WHITEMARSH TOWNSHIP

TO: PLANNING COMMISSION
FROM: Charles L. Guttenplan, AICP, Director of Planning and Zoning
SUBJECT: MATERIAL FOR JANUARY 13, 2026 MEETING
DATE: JANUARY 8, 2026
CC: Vincent Manuele, BOS Liaison
 Krista Heinrich, PE, Township Engineer
 Tim Konetchy, MCPC Planner Liaison

**WHITEMARSH TOWNSHIP
PLANNING COMMISSION MEETING (IN-PERSON)
AGENDA
JANUARY 13, 2026
6:30 PM**

SUBJECT: Tentative Sketch Plan Review – 604-608 Germantown Pike, Whitmarsh Township
MCPC #21-0192-003

PENNDOT HIGHWAY OCCUPANCY PERMIT REQUIRED

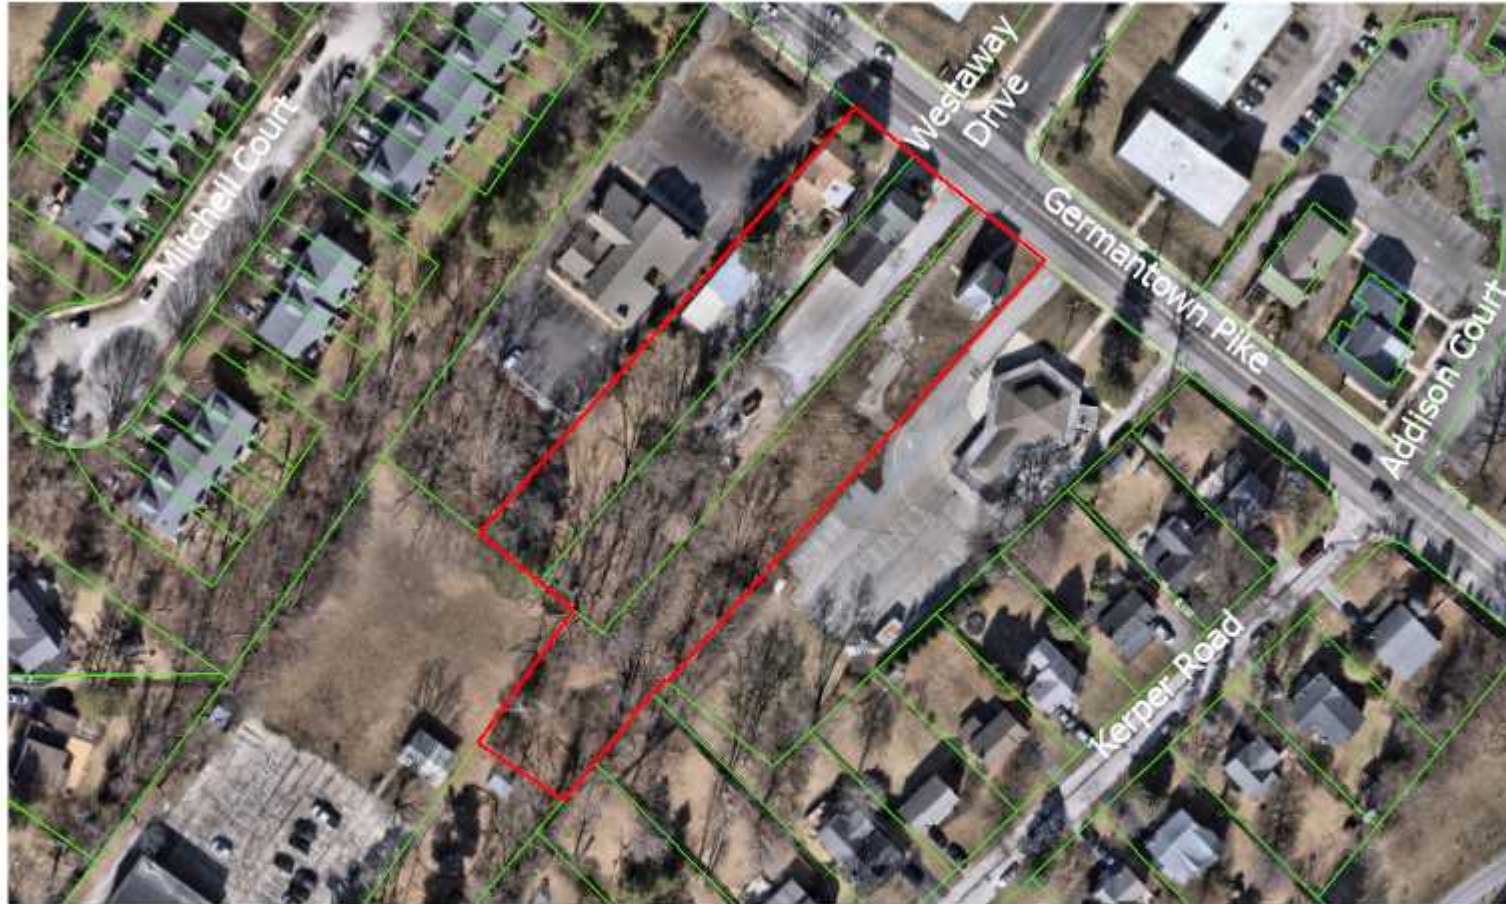
Germantown Pike is a PennDOT roadway and, as such, a PennDOT highway occupancy permit will be required for any work within the right-of-way. The township and applicant are encouraged to begin coordination with PennDOT early on in the process to ensure that ingress/egress points are properly planned for and to avoid future revisions. We have copied PennDOT staff on this letter.

PENNDOT HIGHWAY OCCUPANCY PERMIT REQUIRED

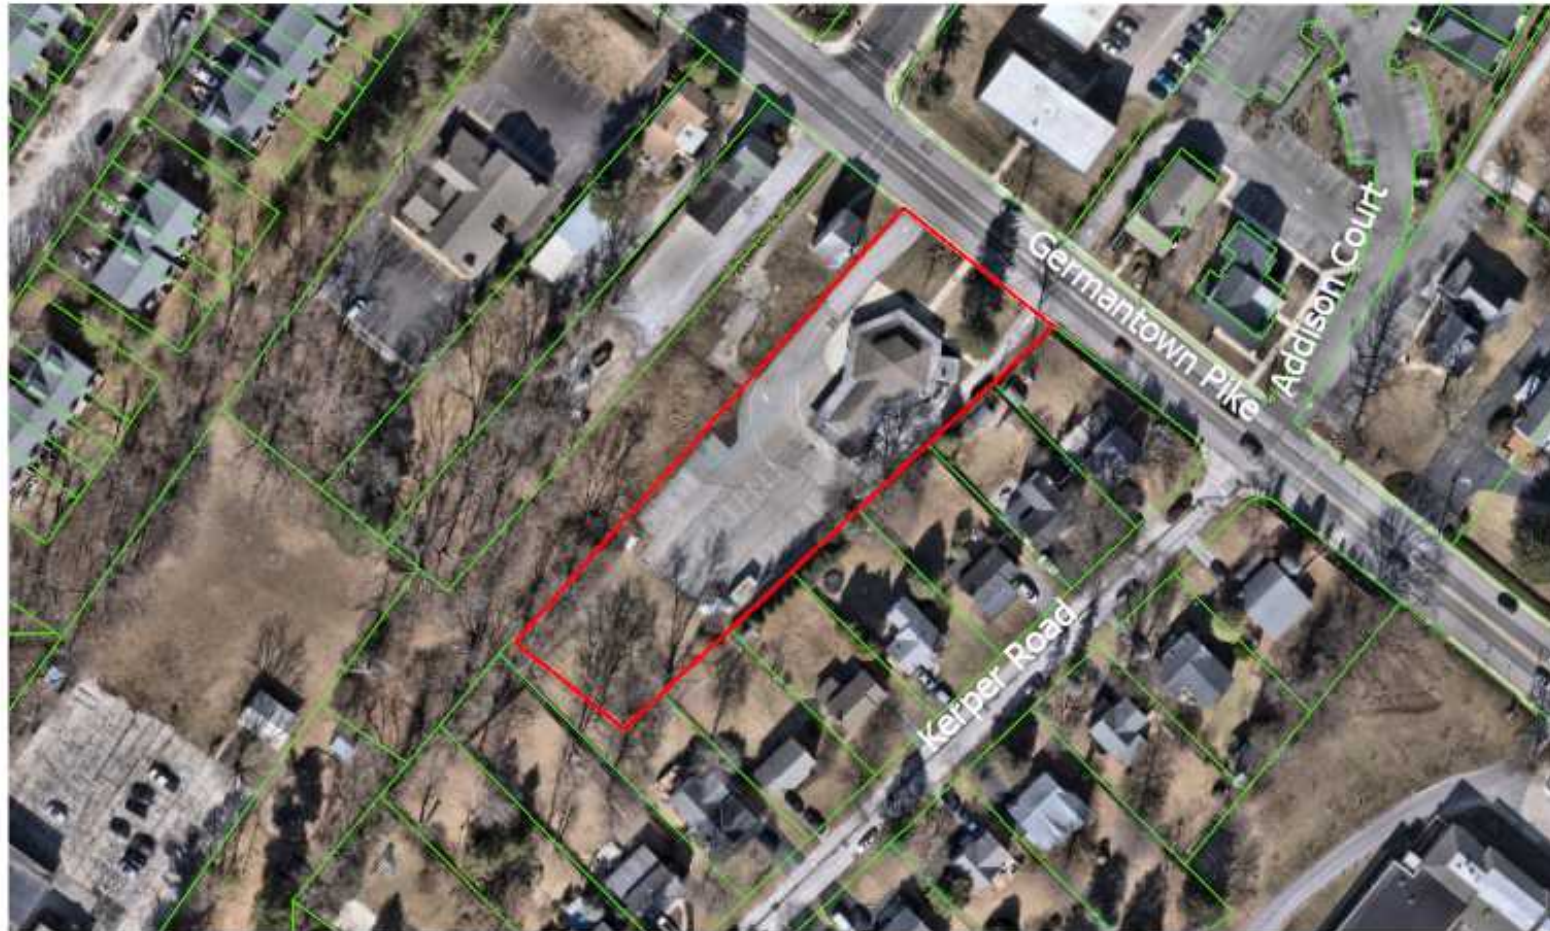
Germantown Pike is a PennDOT roadway and, as such, a PennDOT highway occupancy permit will be required for any work within the right-of-way. The township and applicant are encouraged to begin coordination with PennDOT early on in the process to ensure that ingress/egress points are properly planned for and to avoid future revisions. We have copied PennDOT staff on this letter.
